VILLAGE PLAN COMMISSION AGENDA

ITEM DESCRIPTION: Site & Architectural Review Amendment – Rebman Plumbing located at 700 W Kimberly Avenue

ITEM DESCRIPTION: Preliminary Plat Review – The Blues (Replat of the Condominium Plat – The Blues at the Trails)

FRONT ELEVATION

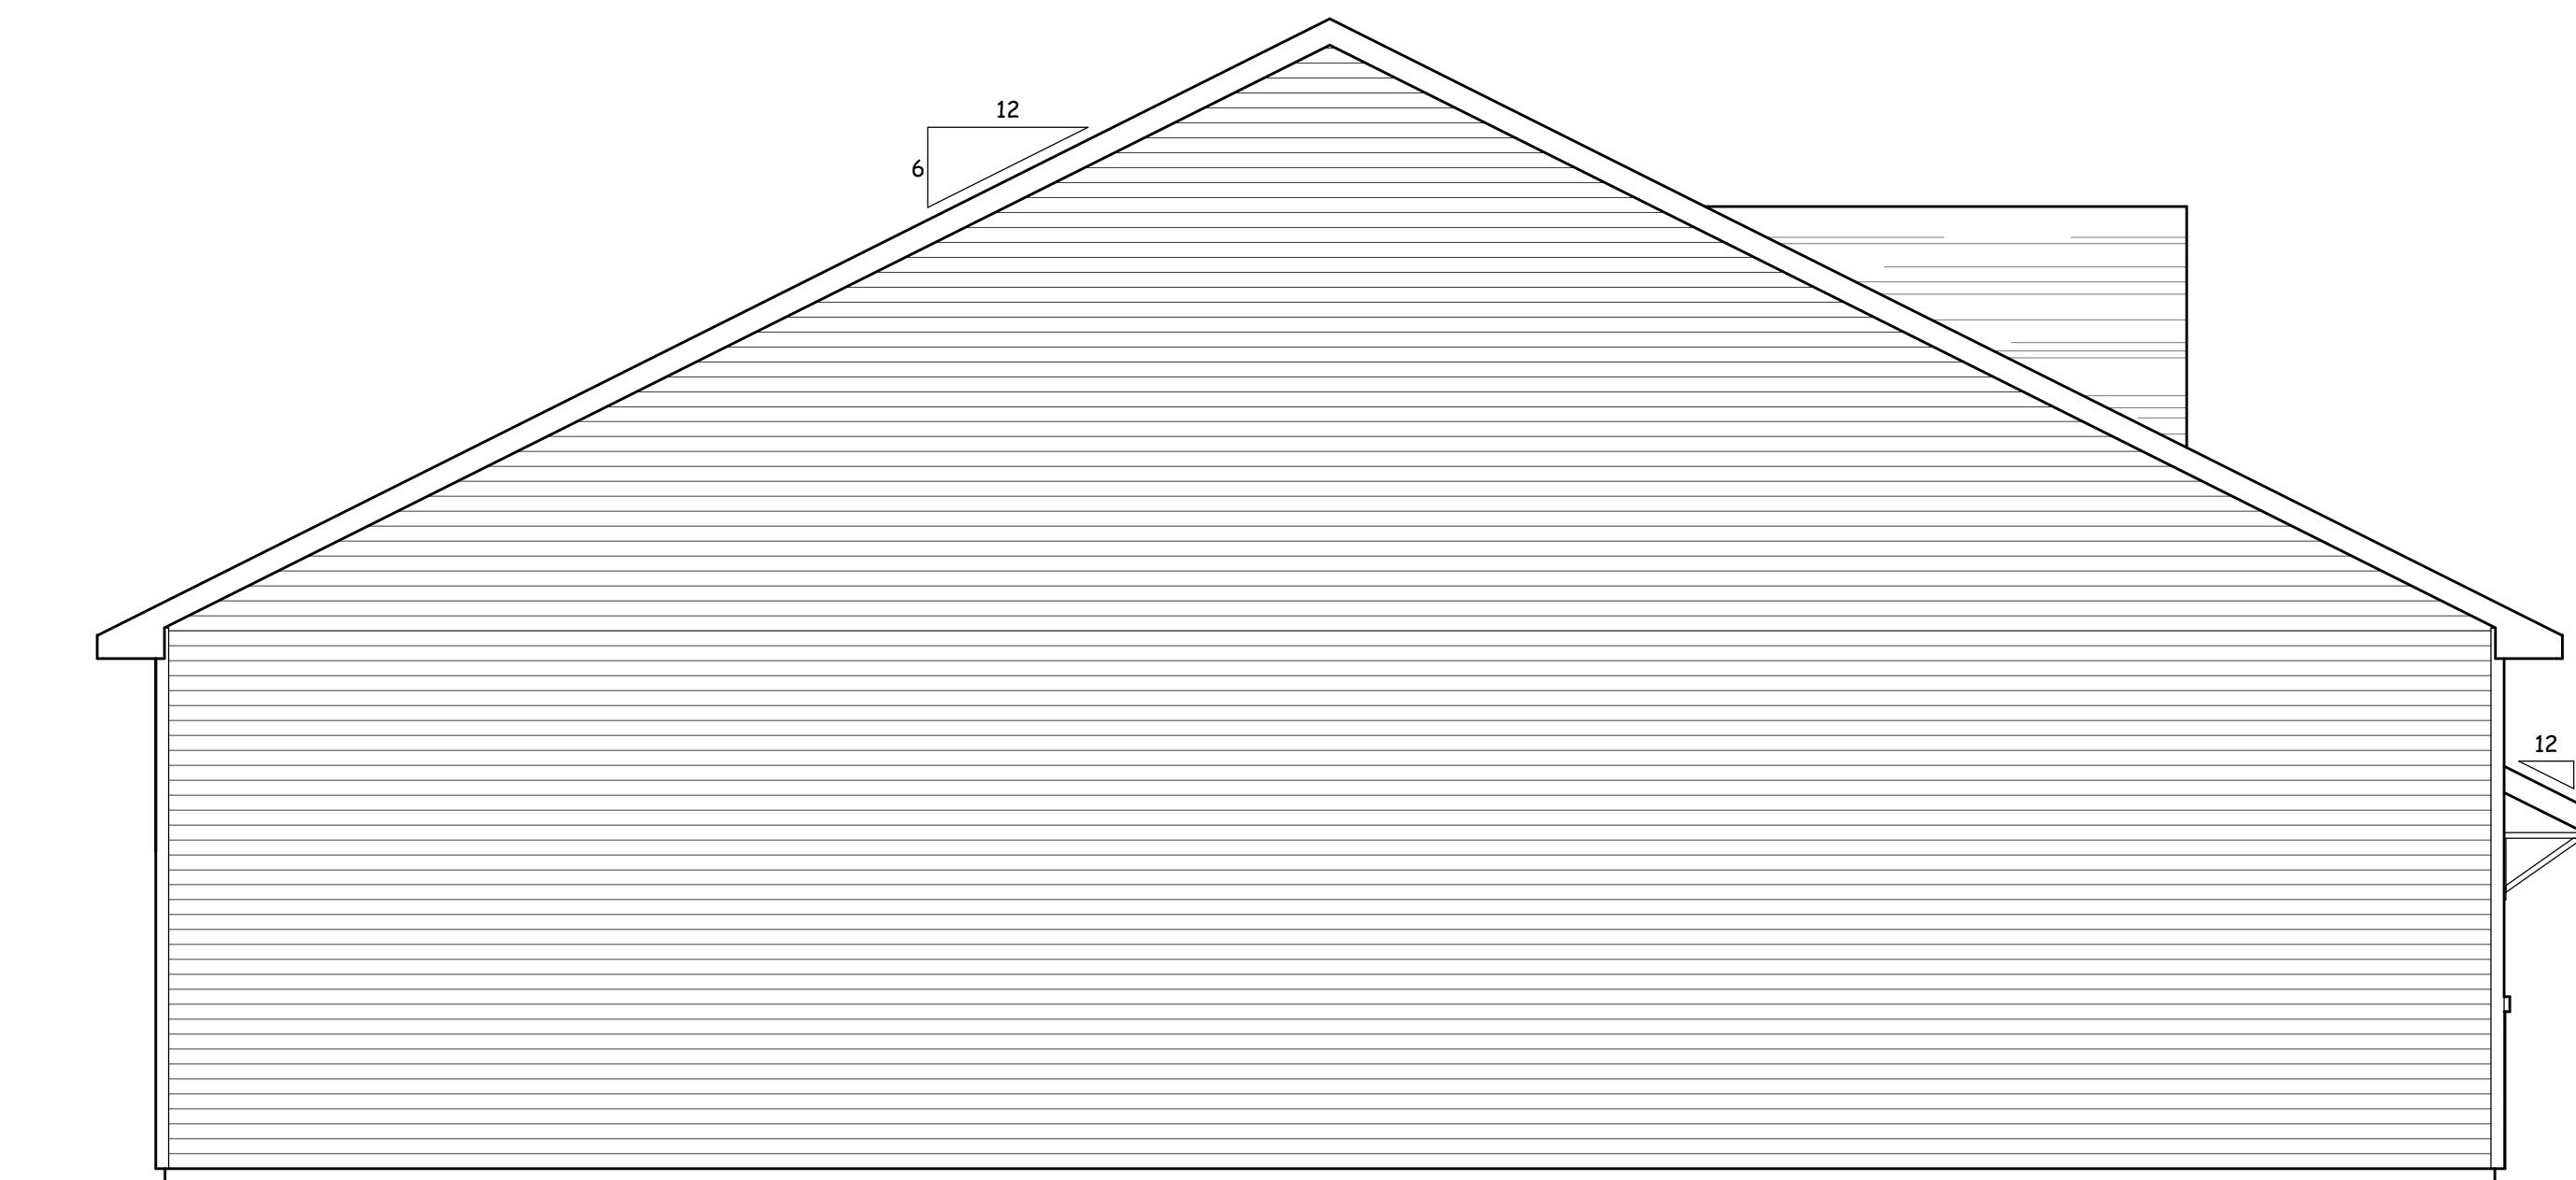
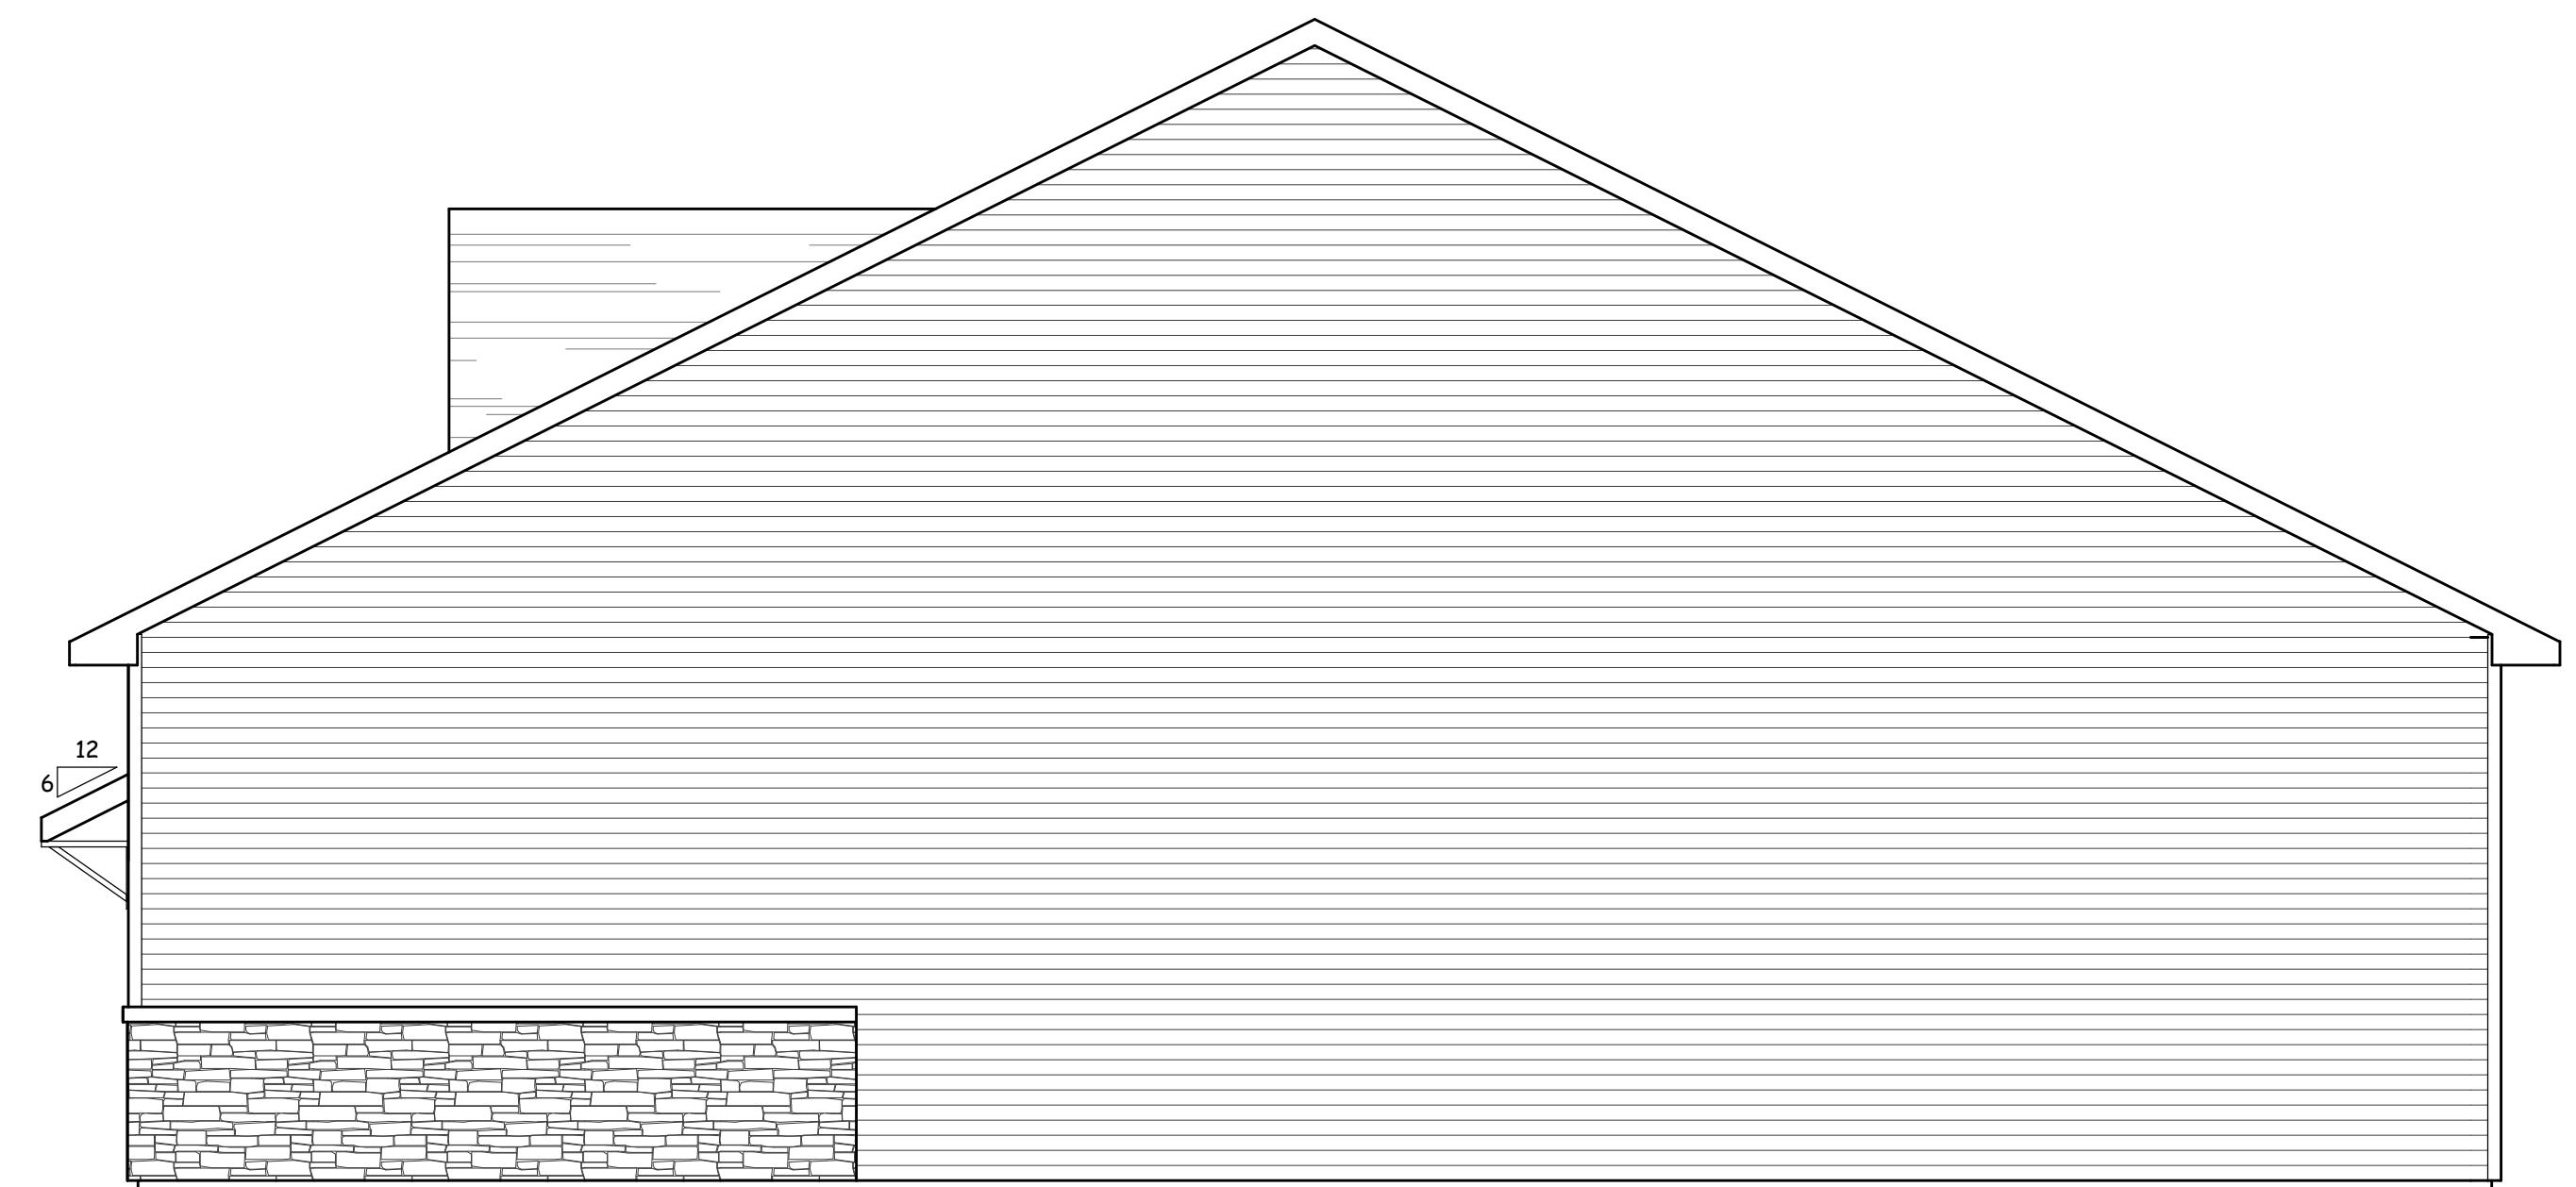
3. The primary exterior façade material will be vinyl siding with decorative brick along the southern and eastern portions of the addition tying it with the existing development.

4. **Site development.** The applicant has implemented many of staff's preliminary recommendations including adding brick to the street facing façade, adding canopy's above the service door to soften the façade, identifying proposed lighting, adding fencing along the eastern property line north of the building to provide screening, adding rear service doors, adding office spaces to align with the business zoning classification, and adding a landscape strip along the W Kimberly Avenue right-of-way. The landscaping plan calls for 16 green mountain boxwoods. Staff is proposing some diversity and trees be planted.

1. Roof drains into a private storm system shall be installed to reduce the runoff off-site.
2. Six of the proposed shrubs shall be replaced with two deciduous trees as well as all landscaping shall meet the vision control requirements.
3. The proposed brick shall complement the existing building and any changes to the existing building shall complement the proposed addition and shall require staff approval.
4. All storage of materials shall be held within the enclosed buildings.
5. All storage of work vehicles, trailers and other equipment shall be stored within the enclosed building or the rear of the building outside of the general public view.

STAFF COMMENTS

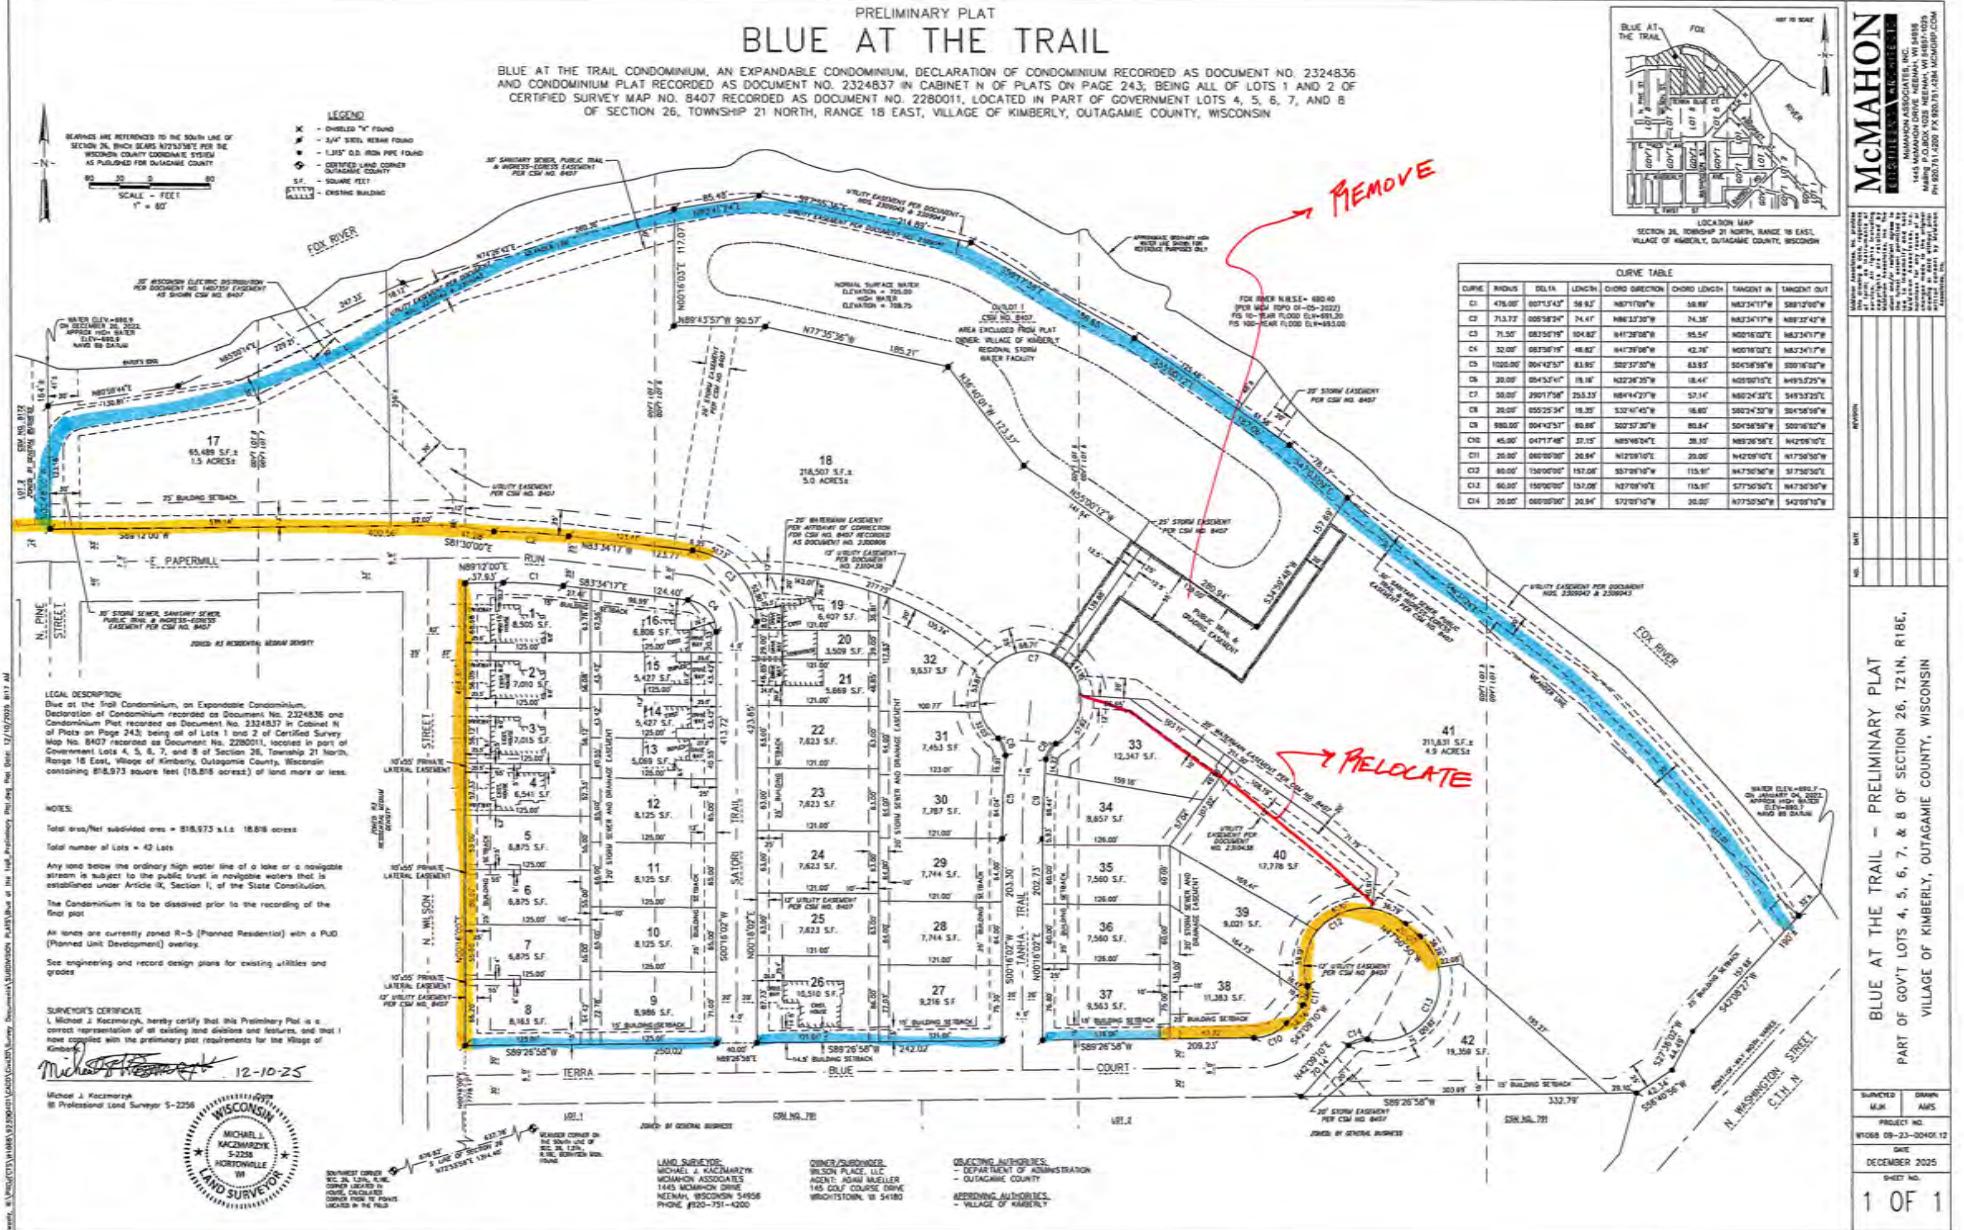
Furthermore, due to the private connectivity of the approved condo development, the final plans previously approved did not indicate any public sidewalks along Satori Trail or Tanha Lane. As currently approved, contrary to the visual of the PUD concept plan, there is only sidewalk planned or installed along the east side of Wilson Street, the north side of E Papermill Run, and the north side of Terra Blue Court.

In an attempt to add necessary pedestrian accommodations, as standard throughout the Village of Kimberly, Staff is recommending additional investigation be completed prior to a final plat submittal to consider additional pedestrian accommodations. There are many constraints including existing utilities, limited right-of-way width, street width and grades that need to be considered. Additionally, due to the lack of sidewalk, the low volume cul-de-sac street, the grades and the location, Staff at this time would not pursue the proposed public trail easement north of Tanha Lane and recommend that this be removed from the final plat.

In terms of utilities, specifically service laterals, due to the reduction in the number of units being proposed, many of the previously installed laterals will have to be properly and professionally abandoned at the developers cost. Likewise, any lot that is not serviced will require the necessary connections to the public service mains.

Lastly, due to the preliminary internal concepts seen for the development of Lot 41, Staff is also recommending that the north line of Lots 33 and 41 be moved further south, reducing their lot width to accommodate appropriate transitioning, landscaping and/or screening from the future multifamily developments.

1. The public trail easement north of Tanha Lane is removed.
2. The north line of Lots 33 and 40 are moved further south to allow for additional buffering between said Lots and future development within Lot 41.
3. All Lots shall be serviced by laterals connected to public utility mains at the developers costs.
4. Any duplicate service utility laterals shall be properly abandoned at the developers costs.
5. Additional investigation shall be completed prior to a final plat submittal to consider necessary pedestrian accommodations.
